## SB-10055017-4010

2011-2014 Fiesta

This article supersedes TSB 13-11-17 to update the Part List/Service procedure.

Figure 1 - Article 14-0021

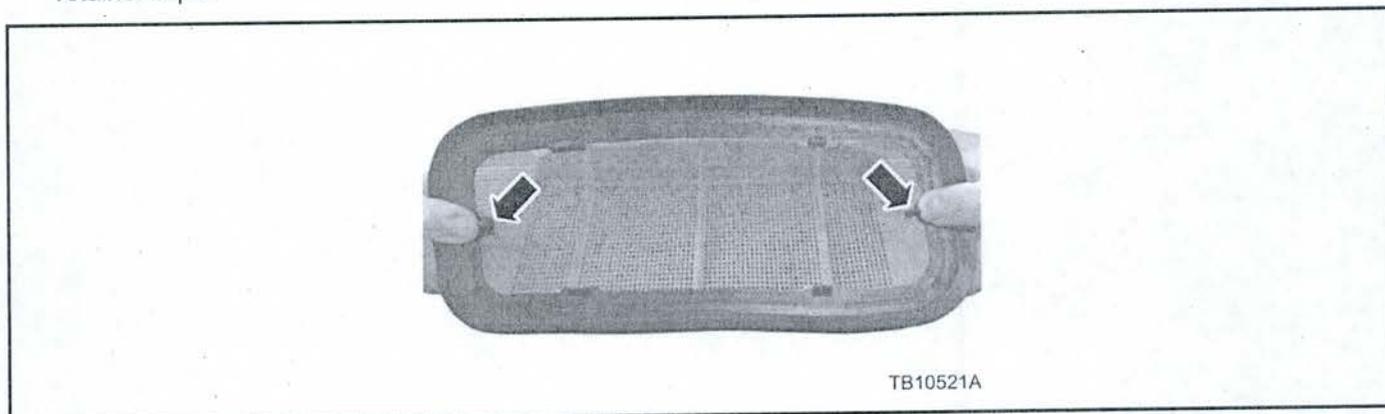
1. Replace the cabin air filter. Refer to Workshop Manual (WSM), Section 412-00.
2. Open hood and remove the cowl panel grille. Refer to WSM, Section 501-02.
3. Remove the screen assembly from the bulkhead.
4. Install the new screen assembly. (Figure 1)
  - a. Position fingers at the horizontal locator tabs and place screen into position.
  - b. Feel the opening in sheet metal with the back of your fingernails and position screen left and right until you feel it is centered in opening.
  - c. Seat the bottom tabs first, pull out fingers and pivot top towards opening to seat the upper tabs. There will be a pop or click sound to know screen is locked in position. Check that screen is snug but do not pull and damage the retainer clips.
